**MEMBER ONE FEDERAL  
CREDIT UNION  
FIELD REVISION #1**  
202 4TH STREET, N.E.  
CITY OF ROANOKE, VIRGINIA

**PHASE I & II  
UTILITY PLAN**

**C08**

**FIELD REVISION #1**

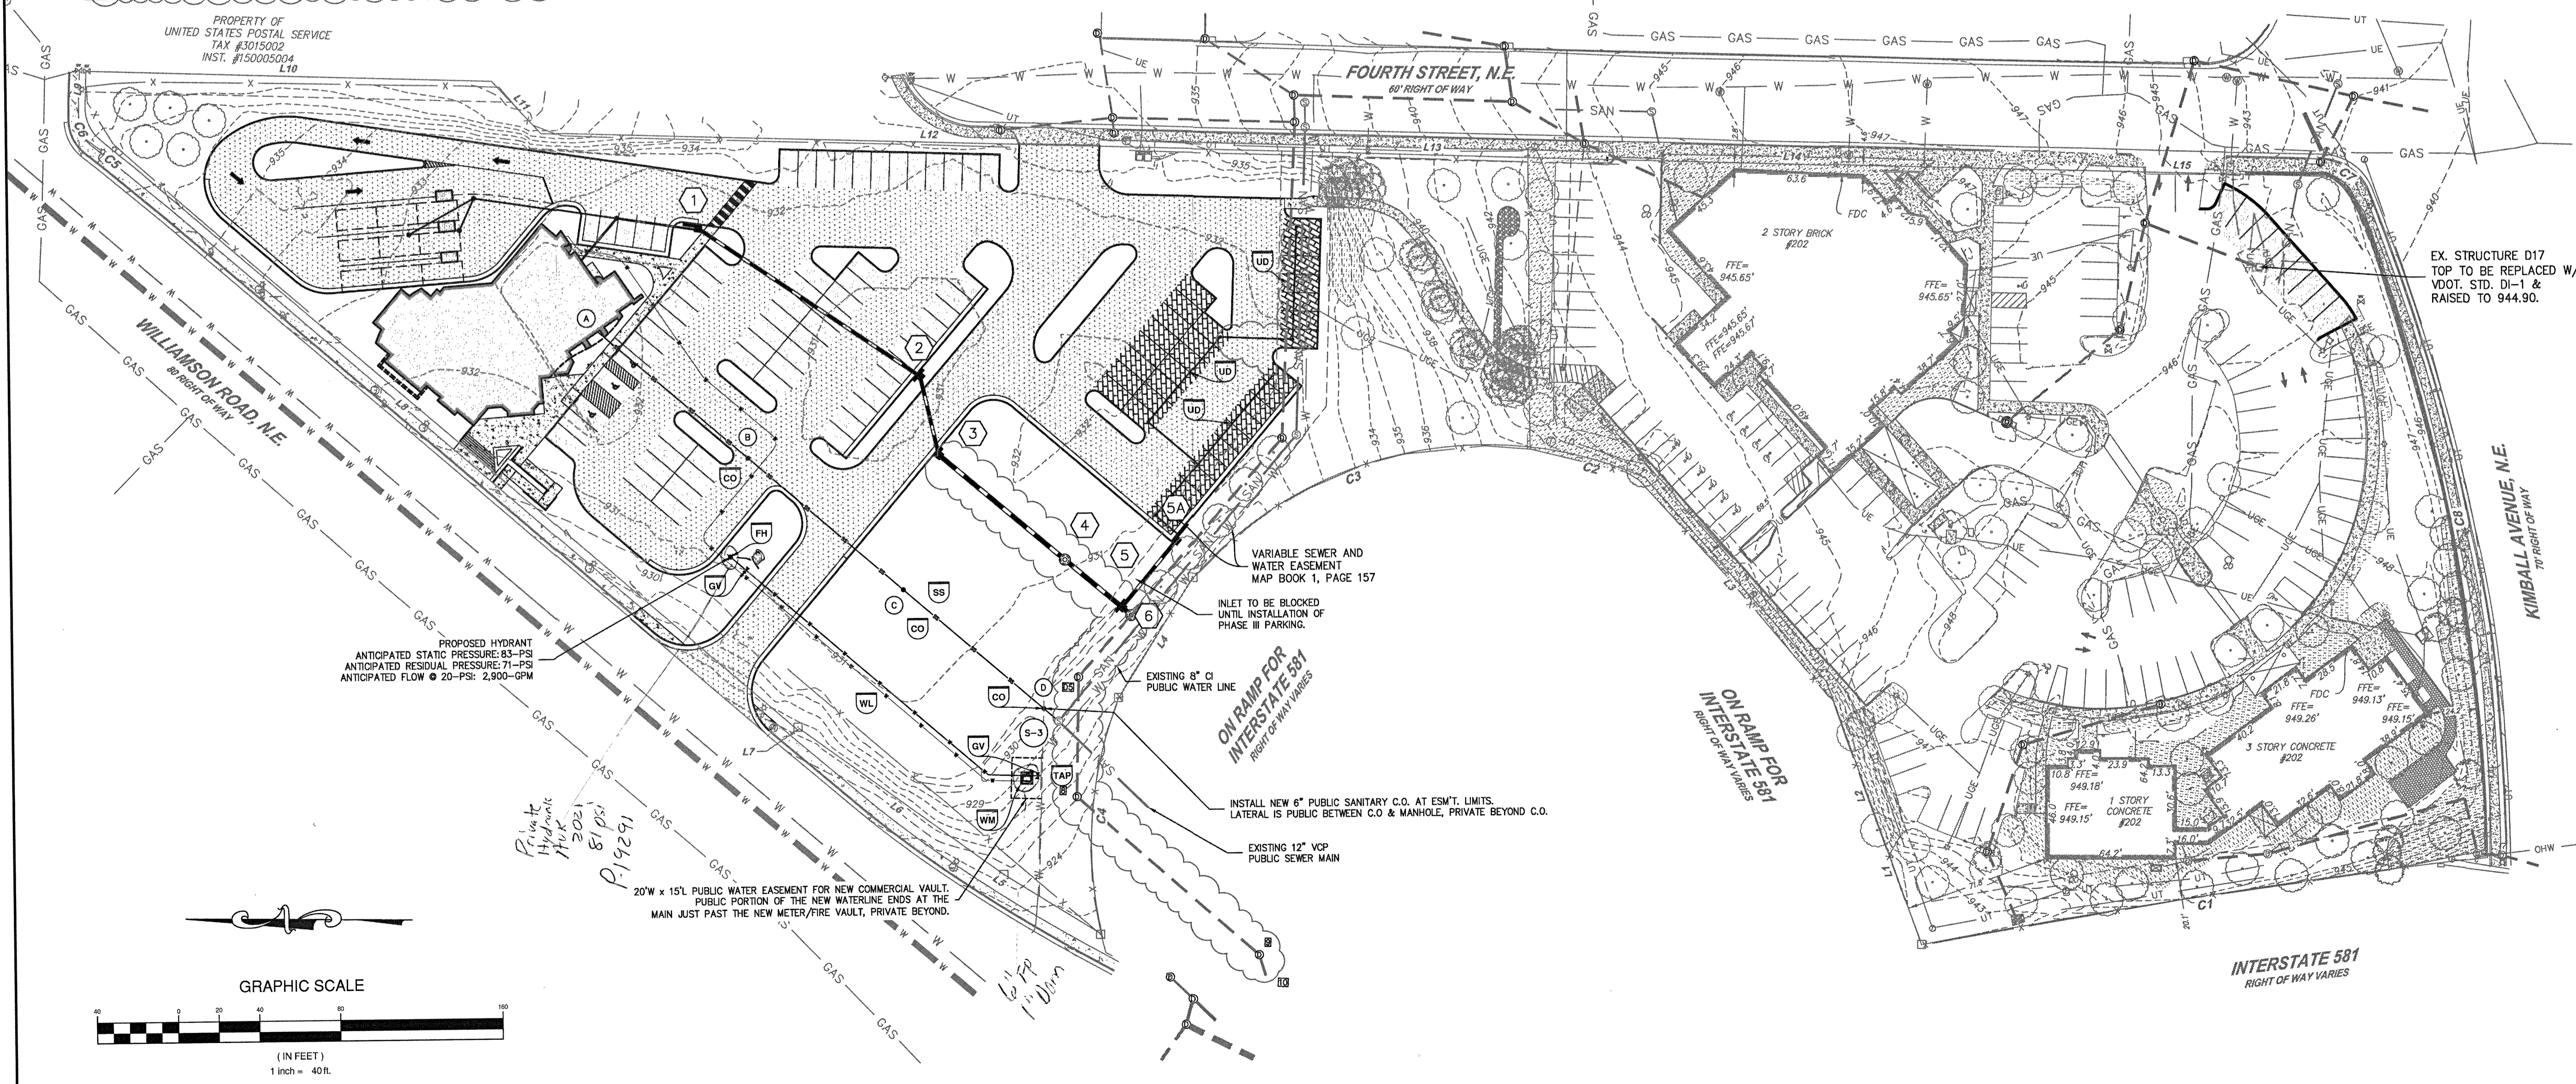
- UPDATED STORM RUN FROM STRUCTURE 3 TO STRUCTURE 10.
- CONTRACTOR TO VERIFY WITH ENGINEER CONNECTION TO STRUCTURE 'EX' IN PHASE IV OF CONSTRUCTION.
- UPDATED STRUCTURE TABLE ABOVE.
- UPDATED UNDERDRAIN CONNECTIONS.
